DESIGN REVIEW COMMITTEE

September 11, 2024

Andrew Catania, Vice President, Development Acquisitions
VC Renewables
110 Edison Place, Suite 312
Newark, NJ 07102
Re: DRC Letter of Recommendation – Medway Grid, LLC - Battery Energy Storage System

The DRC recommends the pattern of “Ledge Stone” in the grey color tone as proposed by the applicant and illustrated here in figure 1

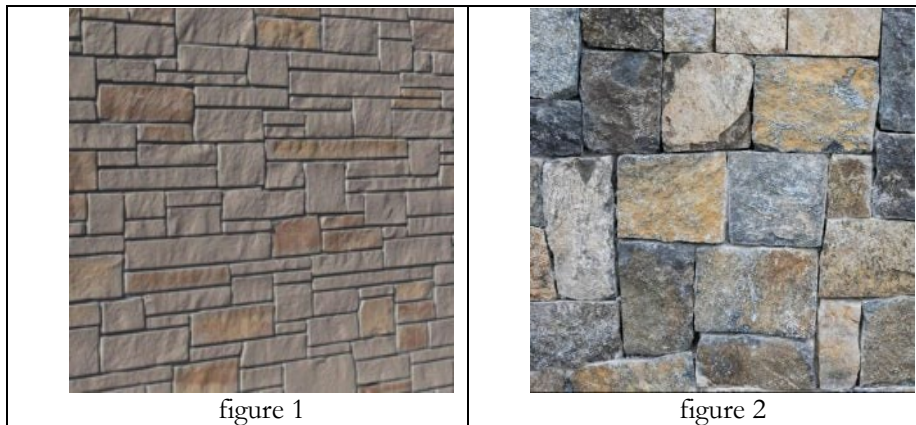
- This pattern includes a varied color pattern to simulate natural stone. It has been indicated to the DRC that the coloration to this wall system is done in the field at the time of installation and can include assorted color tones and shades.
- The DRC recommends in addition to the grey and oxidized iron color, a darker gray color be included to more closely replicate the stones found in the area as illustrated in figure 2.
- This coloration should be randomized and varied, so as not to develop a pattern and appear artificial.
- The coloration is meant to be permanent, and the maintenance plan should assure it remains.
- The maintenance plan should also provide solutions for vandalism and graffiti as well as damages of any kind that effect or alter the appearance of the material.
- The joining columns and headers should match the grey color recommended.
